Release Note - Restrictions in Energized to Trip Applications

- CPU OS release <= **06.05** for central modules of the H41q/H51q product family

Figure 1: Non-Recommended Wiring

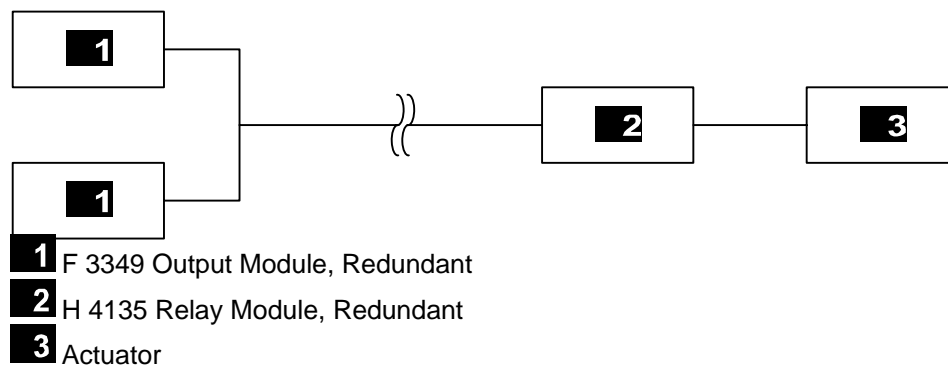
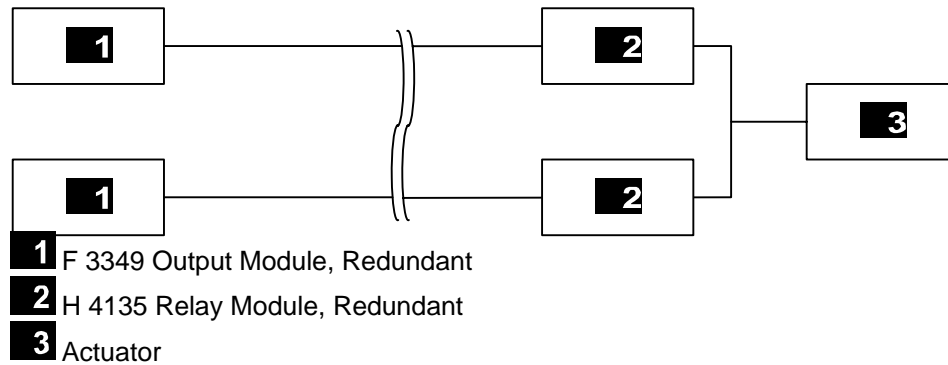
If F 3349 output modules are not wired as recommended in connection with a H 4135 and under additional conditions, the relay could be activated when the PADT logs into the controller. By this, devices connected to the relay might be activated causing shut-down of the concerned plant component.

- H41q, H51q HRS system
- Two redundant F 3349 switch a non-redundant H 4135 relay
- Energized-to-trip application
- In HB-BLD-4 function block,
the input "Max. Time Inrush current in ms,.." is set to a value > 0

Combined with a prolonged waiting time at the function block HB-BLD-4's input "Max. Time Inrush current in ms,..", the asynchronous test pulses of the two output module's line monitoring may add and therefore activate the relay input up to the waiting time.

Use redundant H 4135 relay modules and wire them as specified in Figure 2:

Set the input "Max. Time Inrush current in ms,.." of the HB-BLD-4 function block to 1 ms.

This wiring prevents the test pulses from overlapping and ensures the wished functionality.

By making the relay H 4135 redundant, the required SIL can be guaranteed for energizing to trip applications.
